CITY OF EL PASO, TEXAS
AGENDA ITEM DEPARTMENT HEAD'S SUMMARY FORM

SUBJECT: 2025 Proposed Thoroughfare System Amendment for Santa Fe Street, Missouri Avenue, Durango Street, and Franklin Avenue

City of El Paso – City Plan Commission Staff Report

Application Type: Amendment to the 2025 Proposed Thoroughfare System
CPC Hearing Date: December 6, 2012
Staff Planner: Kevin Smith, 915-599-8201, smithkw@elpasotexas.gov

Exhibit "A"

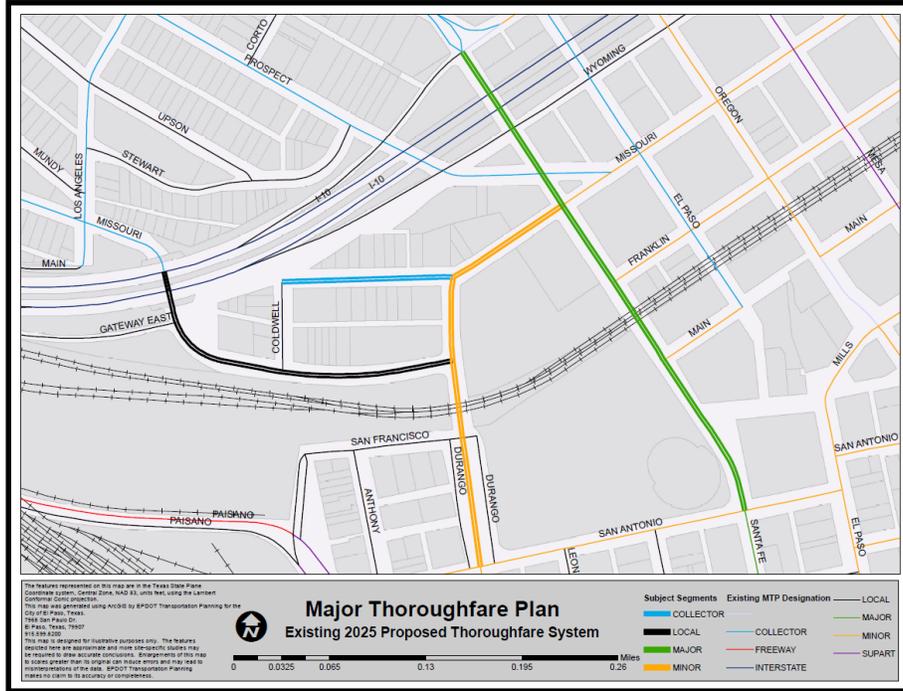
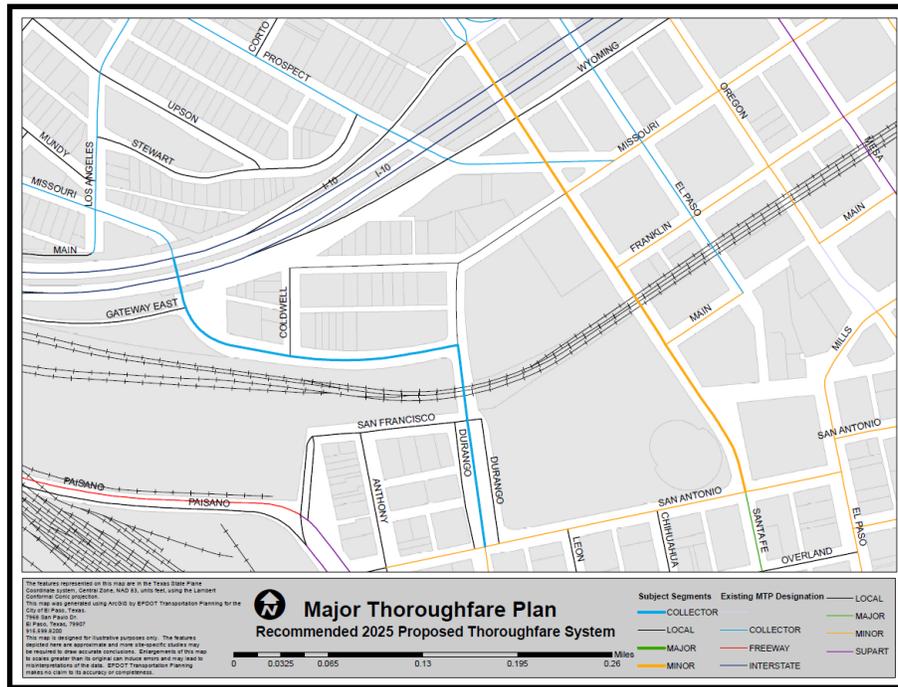
- Delete a portion of Durango Street from Missouri Avenue to Franklin Avenue currently designated as a Minor Arterial;
- Downgrade a portion of Durango Street from Franklin Avenue to San Antonio Avenue from a Minor Arterial to a Collector Arterial;
- Downgrade a portion of Santa Fe Street from Yandell Drive to San Antonio Avenue from a Major Arterial to a Minor Arterial;
- Add Franklin Avenue as a Collector Arterial from Interstate Highway 10 to Durango Street; and
- Delete a portion of Missouri Avenue from Coldwell Street to Santa Fe Street currently designated as a Minor Arterial and Collector Arterial;

ATTACHMENT 1

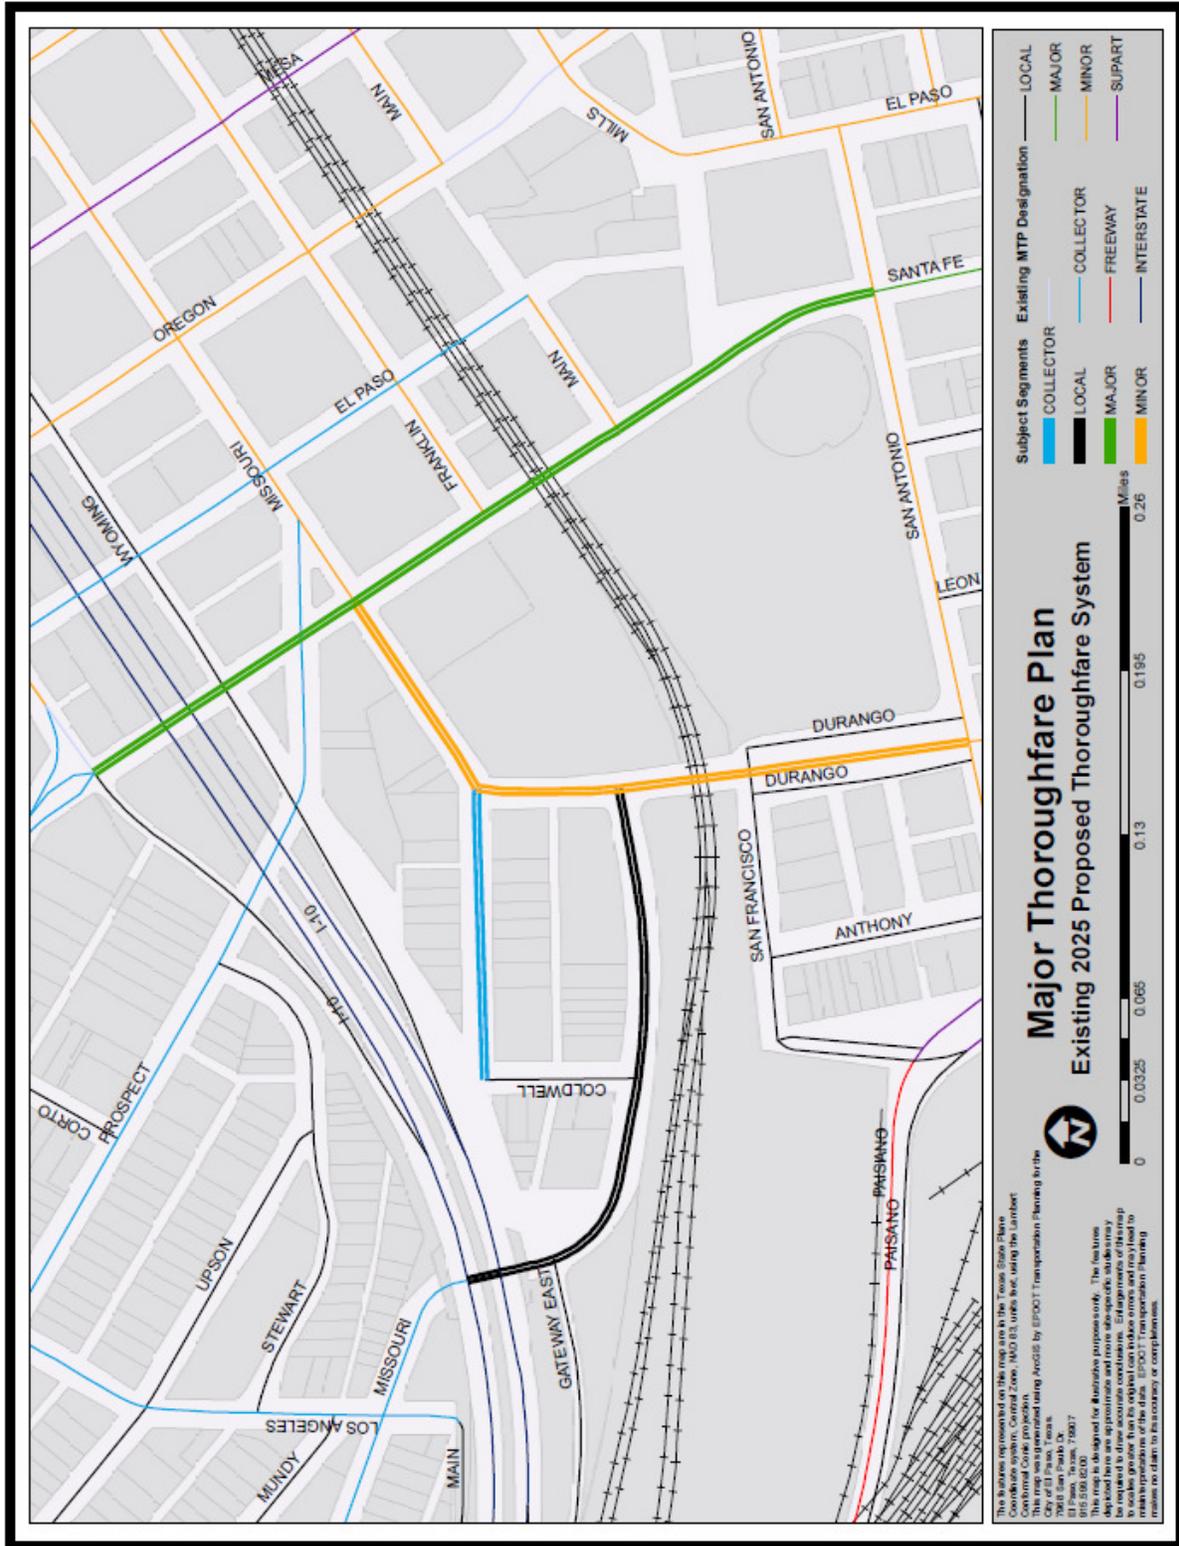
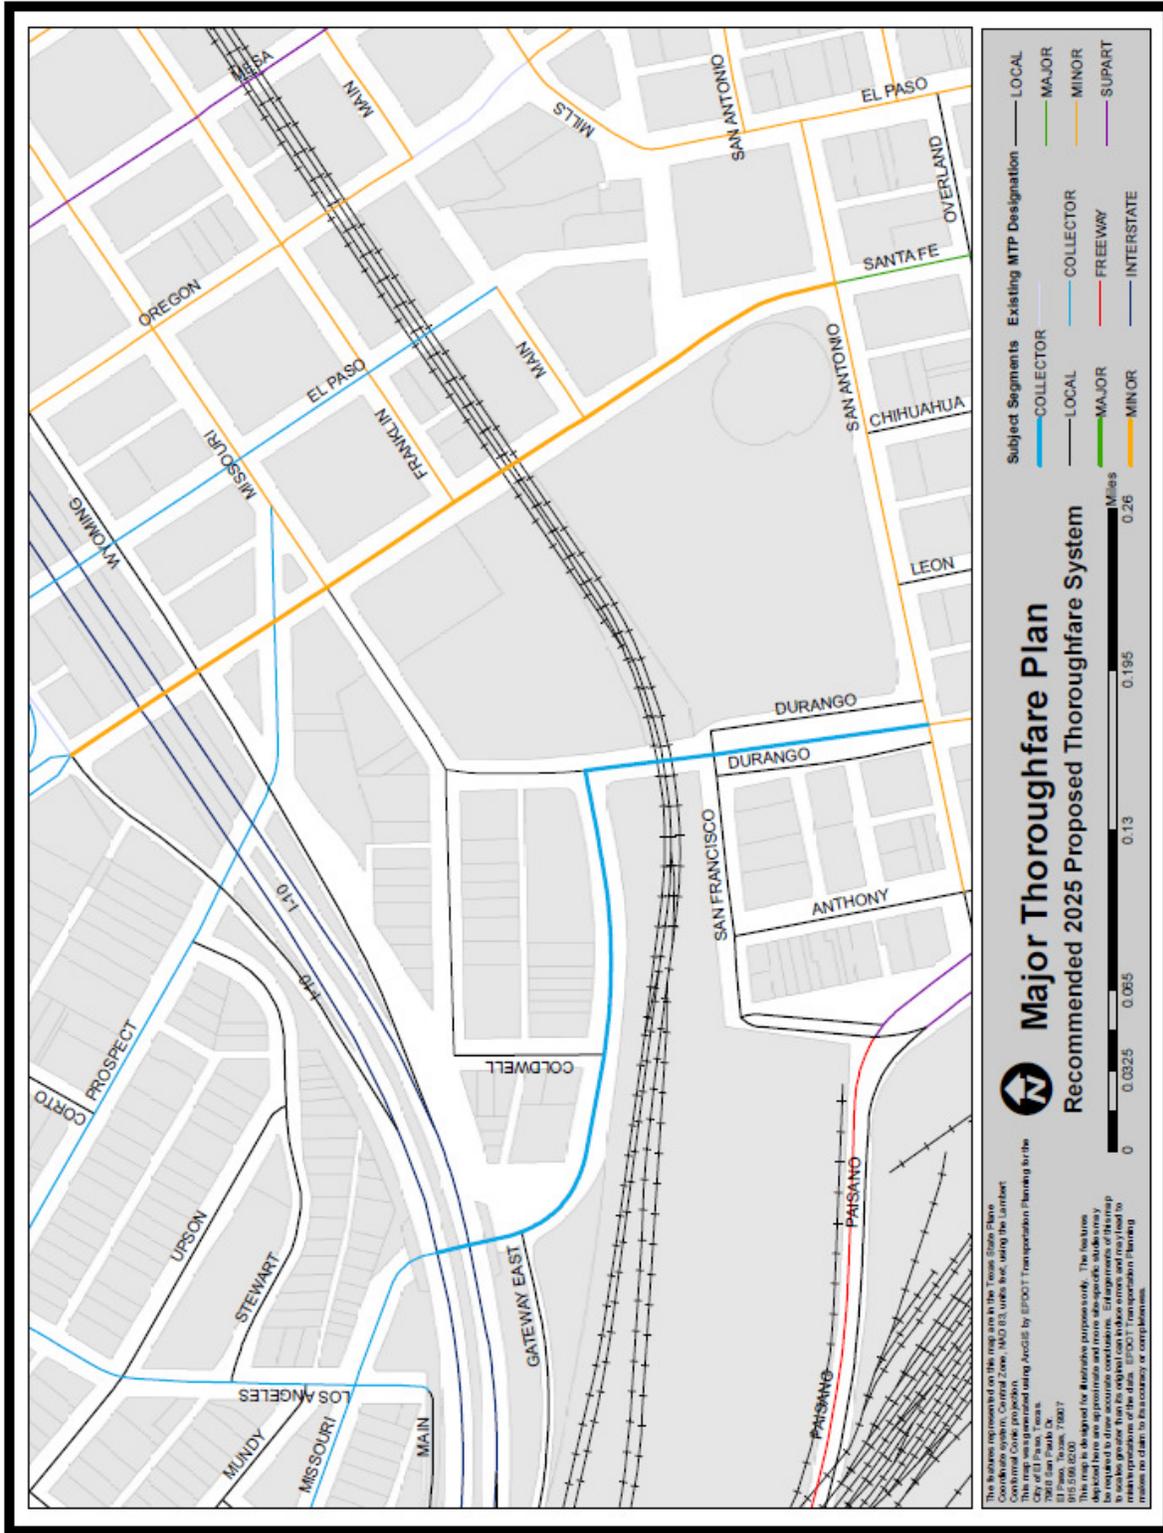
- Delete Durango Street from Missouri Avenue to Franklin Avenue currently designated as a Minor Arterial.
- Downgrade Durango Street from Franklin Avenue to San Antonio Avenue from a Minor Arterial to a Collector Arterial.
- Downgrade Santa Fe Street from Yandell Drive to San Antonio Avenue from a Major Arterial to a Minor Arterial.
- Add Franklin Avenue as a Collector Arterial from Interstate Highway 10 to Durango Street.
- Delete Missouri Avenue from Coldwell Street to Santa Fe Street currently designated as a Minor Arterial and Collector Arterial.

- Santa Fe Street would be to match the proposed cross section as shown on Stevens Addition Replat A.
- Conversion of Missouri Avenue, from Santa Fe St. to Durango St., to a one-way westbound road continuing the existing travel direction of Missouri Ave. between

- The proposed addition of Franklin Avenue as a Collector Arterial connects the existing Missouri Avenue collector located north of Interstate Highway 10 in the Sunset Heights neighborhood to the proposed Durango Street collector. Doing so closes an existing gap in the network and provides access to the existing San Antonio Avenue minor arterial.

- Improving the pedestrian elements on Missouri, Durango and Santa Fe by widening sidewalks and providing street trees will enhance pedestrian access and safety.
- The addition of Franklin to the MTP as a collector arterial will improve east-west connectivity. The portion of Missouri from Coldwell to Santa Fe does not function as an arterial and should be deleted from the MTP.
